AMENDMENT OF SOLICITATION/MODIFICATION OF CONTRACT			1. CONTRACT ID CODE		PAGE 1 OF 15 PAGES		
2. AMENDMENT/MODIFICATION NO. AMENDMENT NO. 0005		3. EFFECTIVE DATE 01/14/14		4. REQUISITION/PURCHASE REQ. NO.		5. PROJECT NO. (If applicable) 14-0035	
6. ISSUED BY Officer in Charge of Construction MCI-East 1005 Michael Road Camp Lejeune, NC 28547-2521		CODE N40085		7. ADMINISTERED BY (If other than Item 6) See Item 6		CODE	
8. NAME AND ADDRESS OF CONTRACTOR (No., street, county, State and ZIP Code)				(X)		9A. AMENDMENT OF SOLICITATION NO. N40085-14-R-0035	
				X		9B. DATED (SEE ITEM 11) 12/20/13	
						10A. MODIFICATION OF CONTRACT/ORDER NO.	
						10B. DATED (SEE ITEM 11)	
CODE		FACILITY CODE

Project 14-0035 P-1450 SOF Fires Platoon Storage Facility

**Q-1450 SOF FIRES PLATOON STORAGE FACILITY**

**S-201**

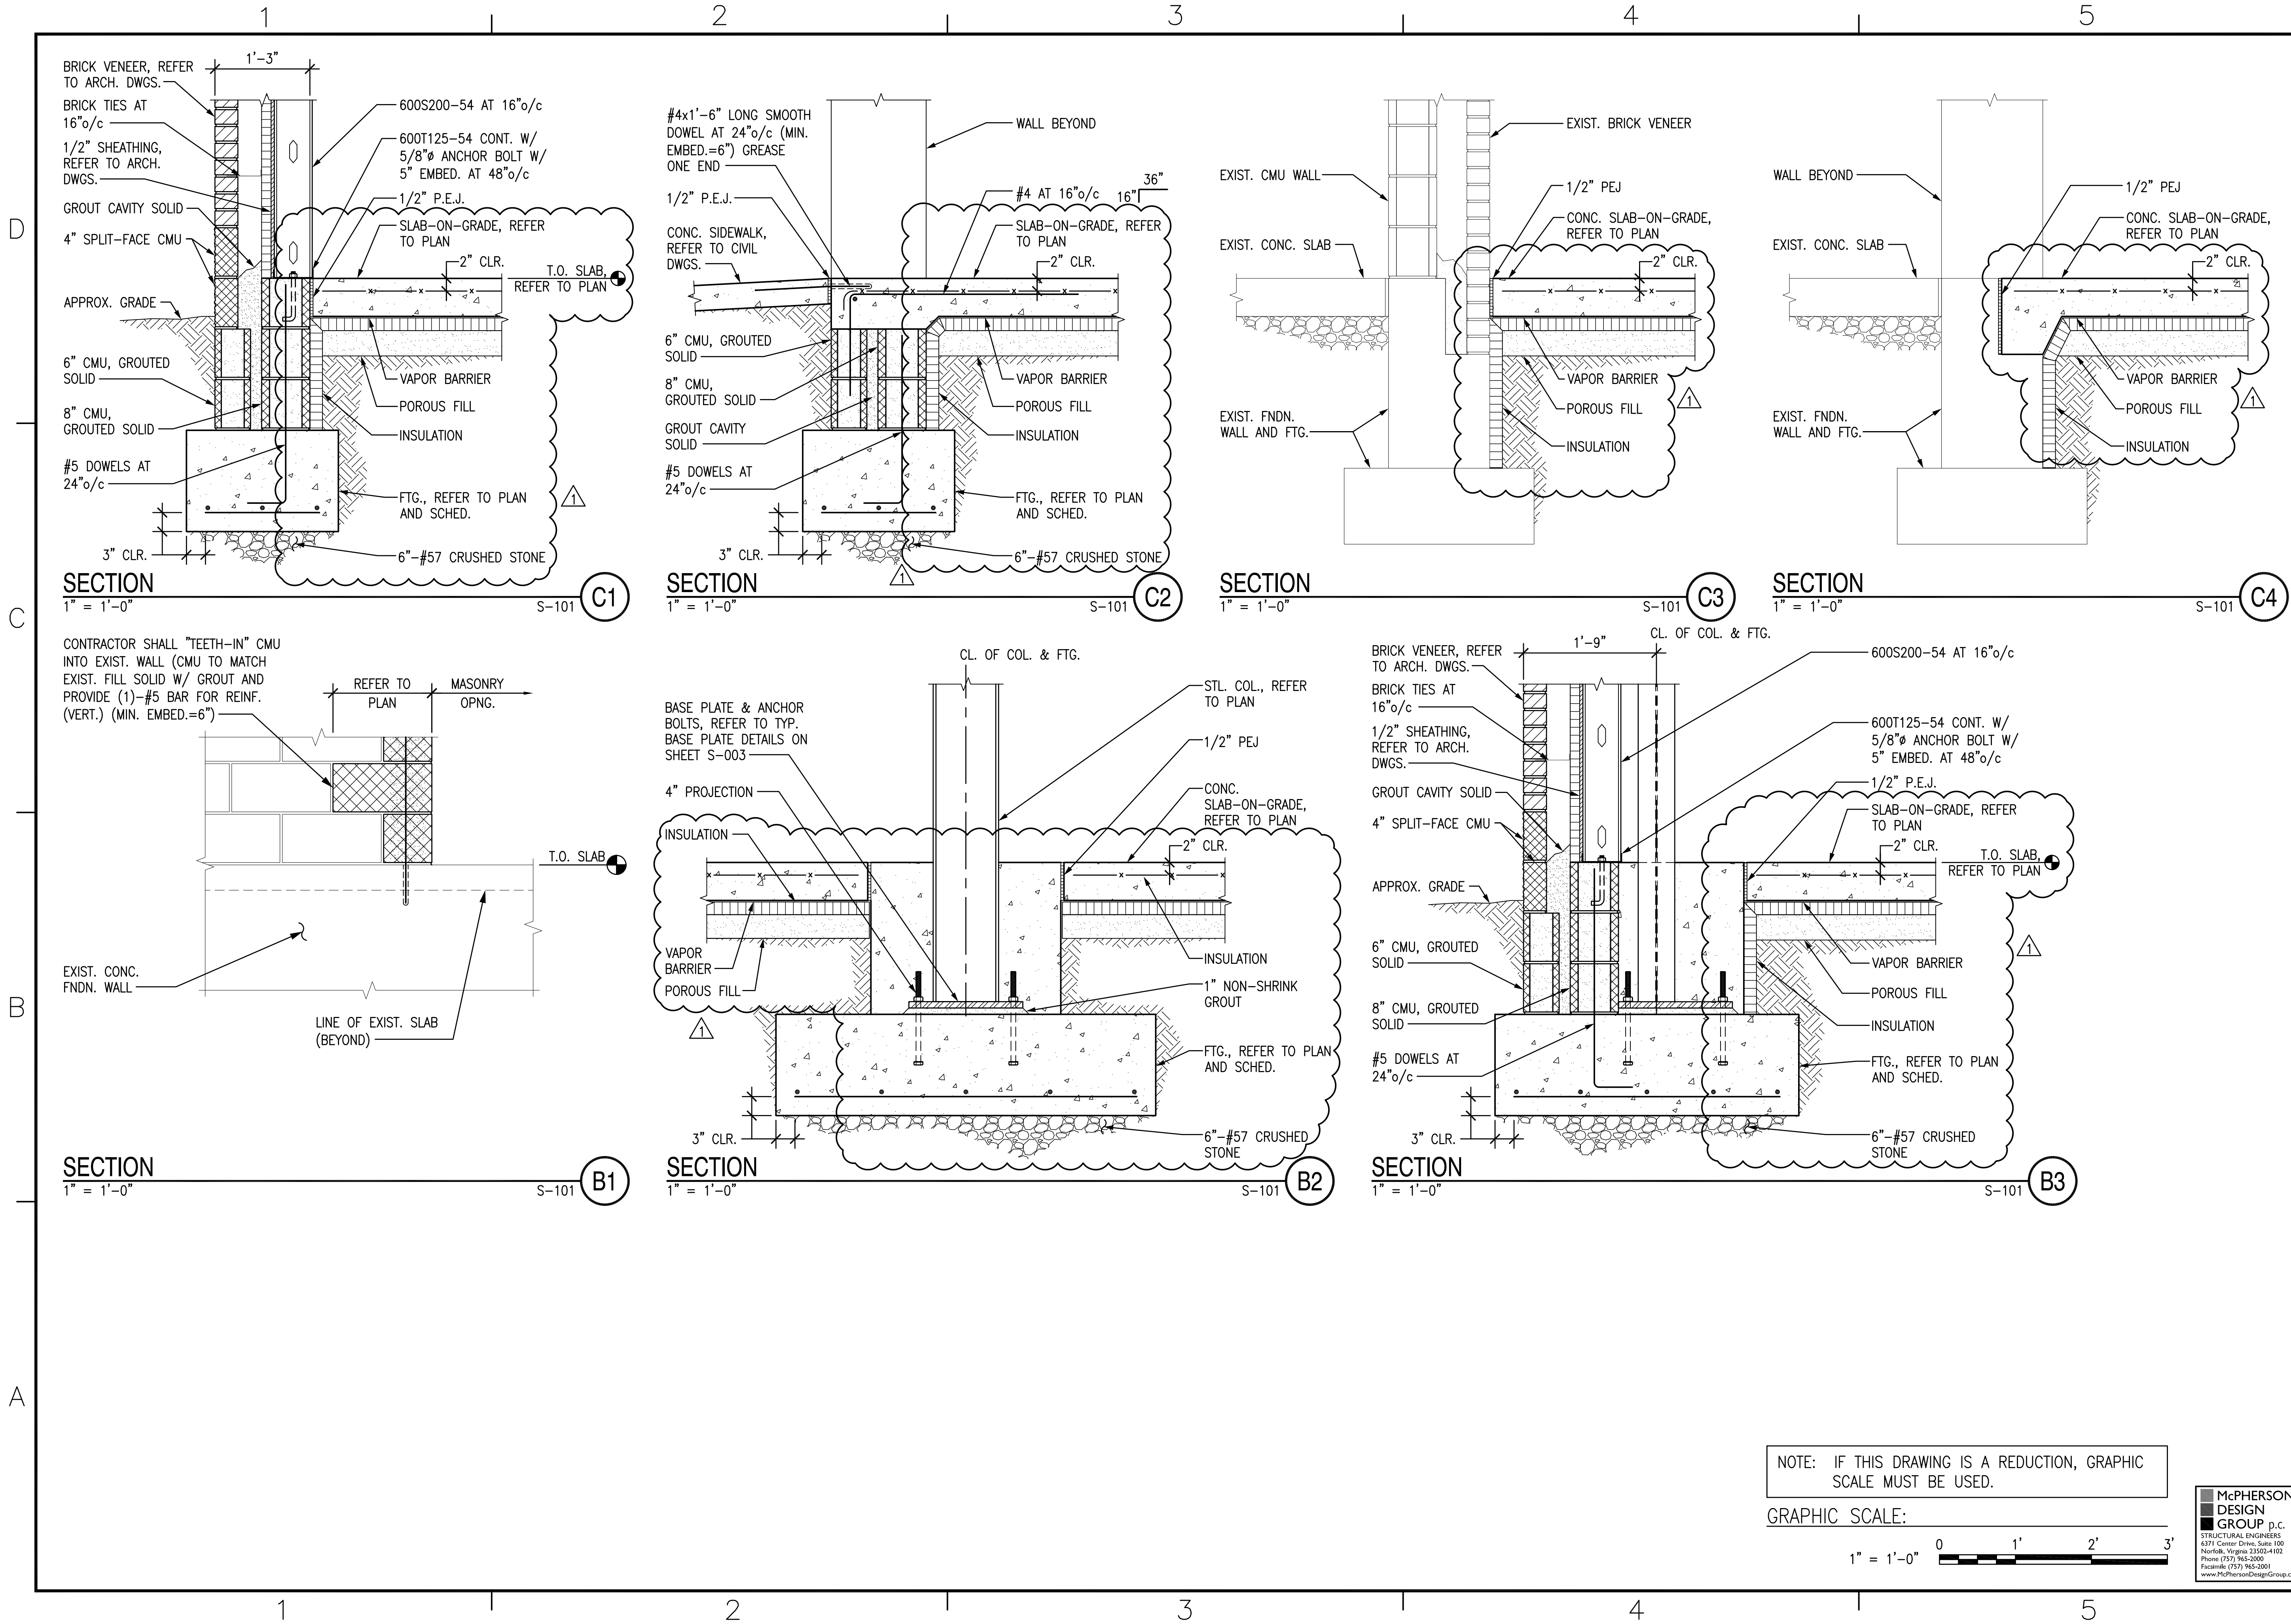
### NAVFAC Dwg. No. 12660971 (S-201)

REPLACE Sheet S-201 with the attached Sheet S-201.

Removed Stone from underneath the slab on grade. Stone still remains under foundations.

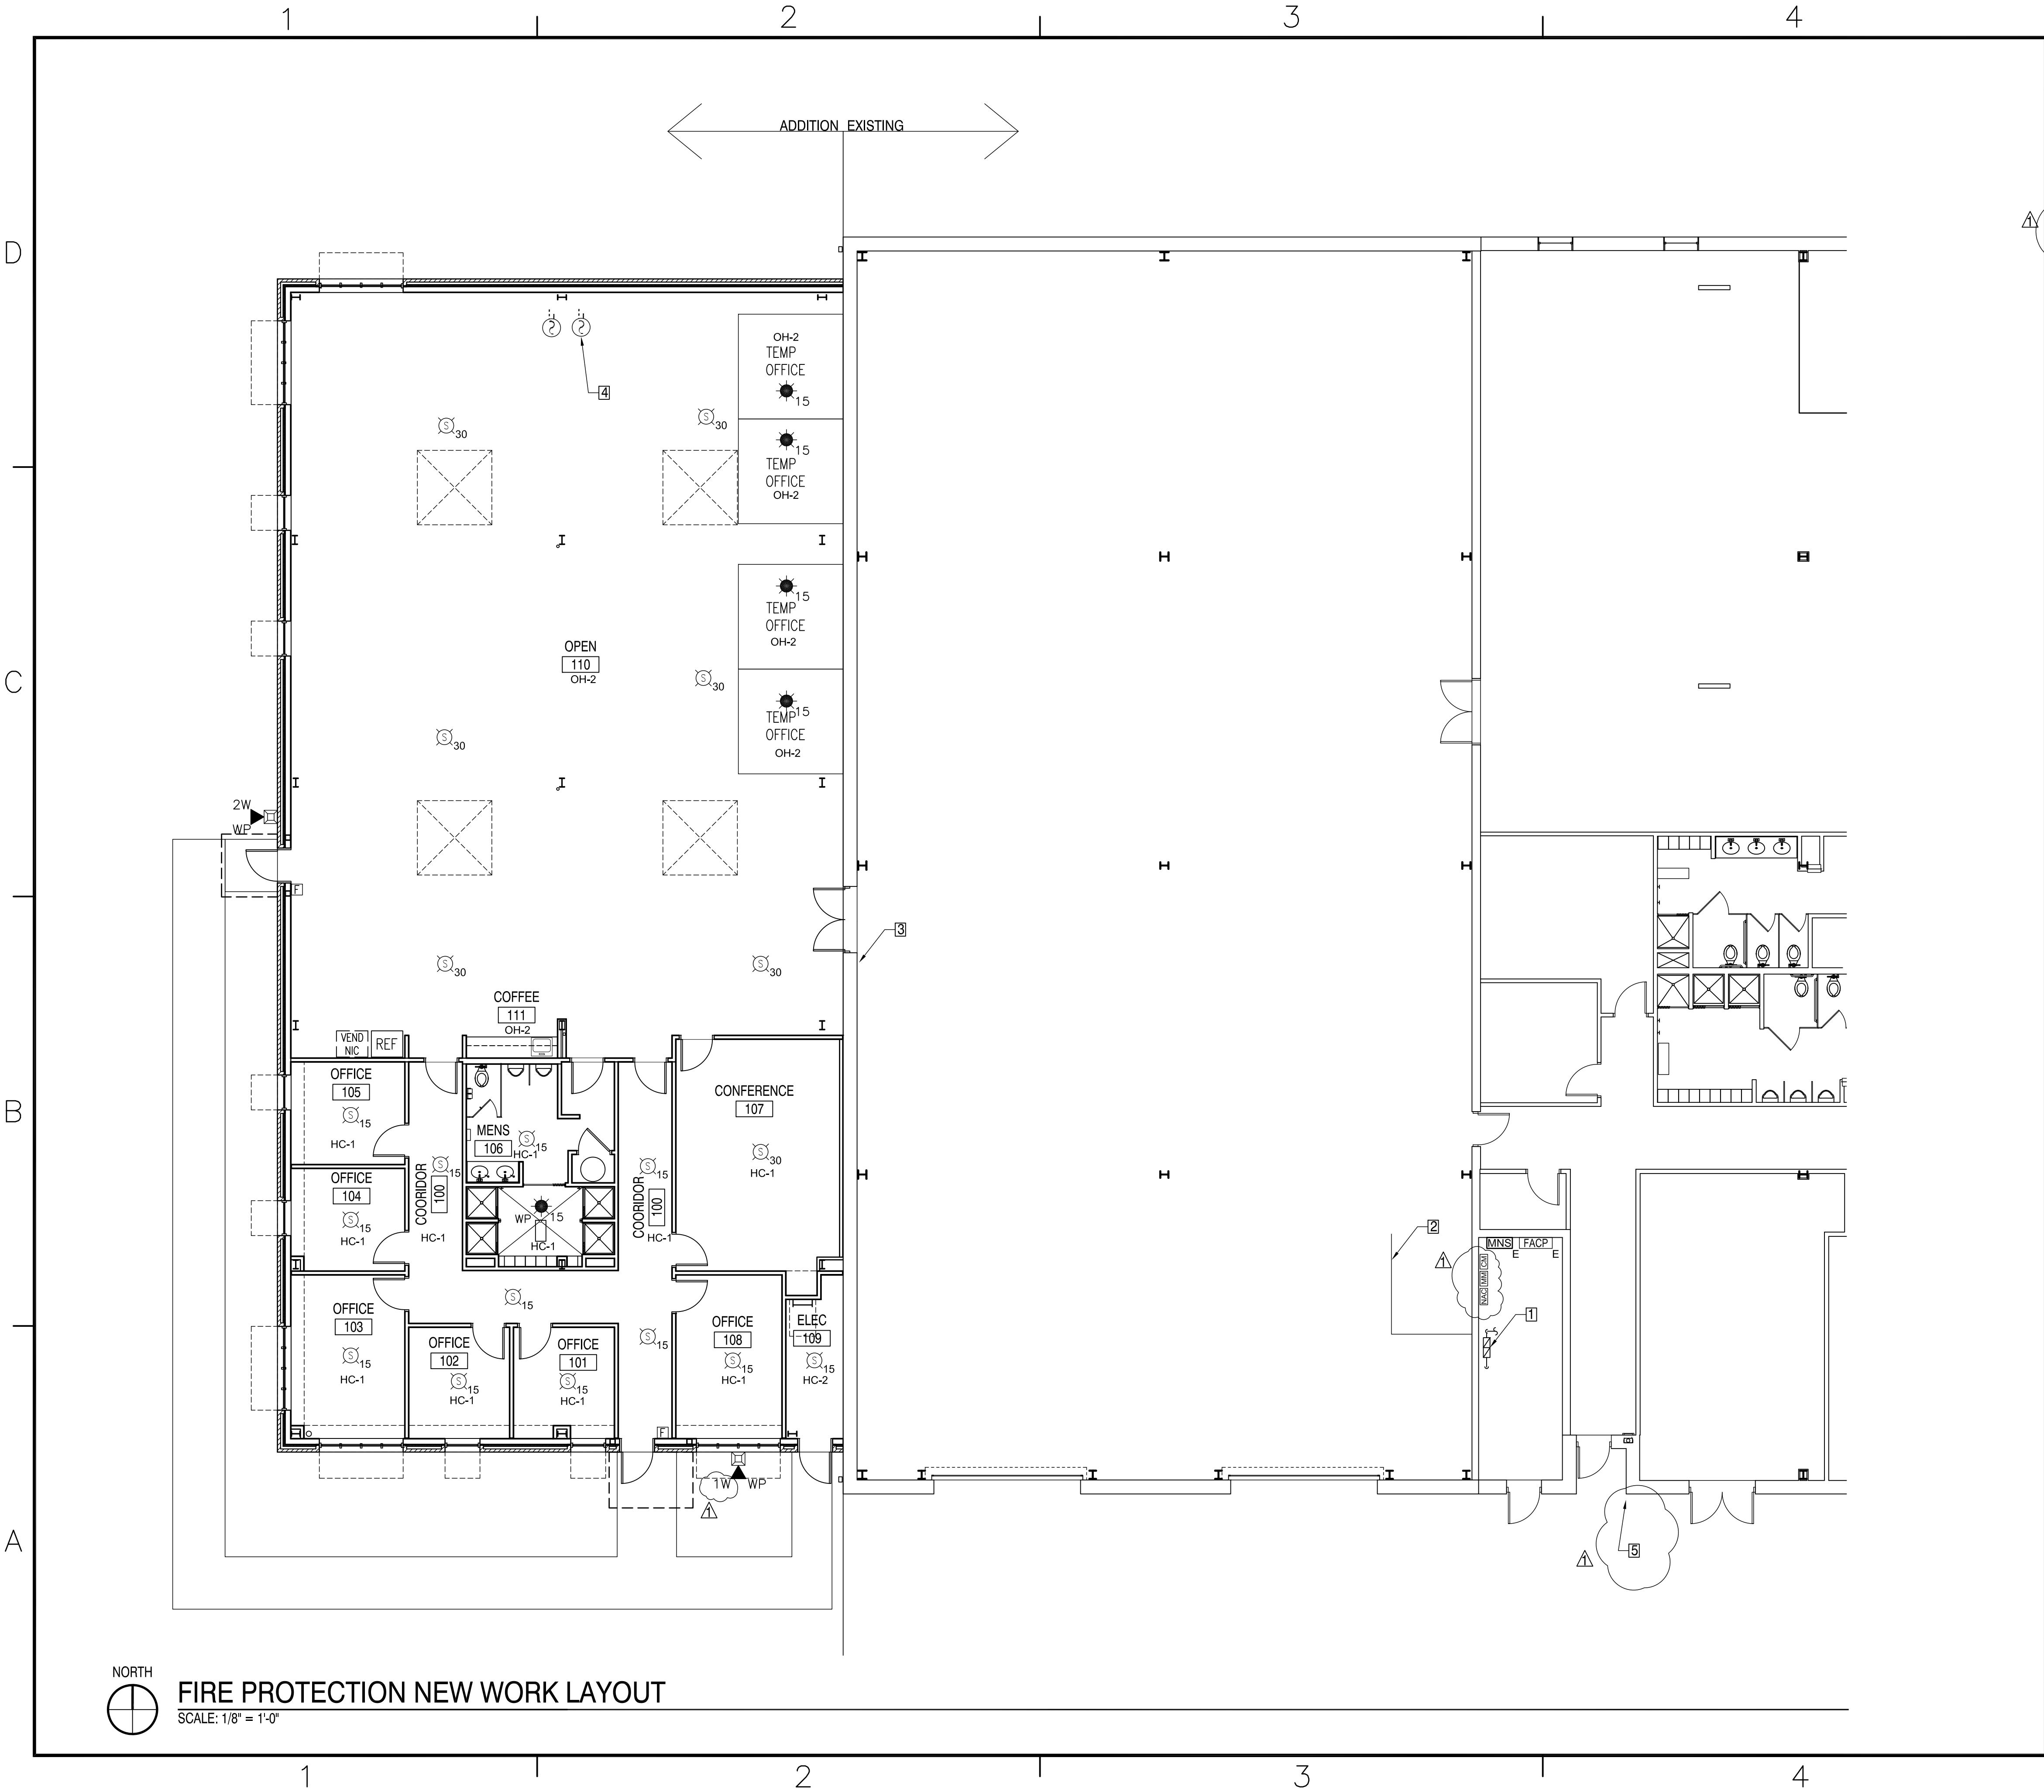
**NAVFAC Dwg. No. 12660991 (F-001)**

REPLACE sheet F-001 with attached sheet F-001

Add 3 general notes.

Add three devices to fire alarm legend.

Move duct smoke detectors from “Fire Alarms” to “Supervisory Signals”.
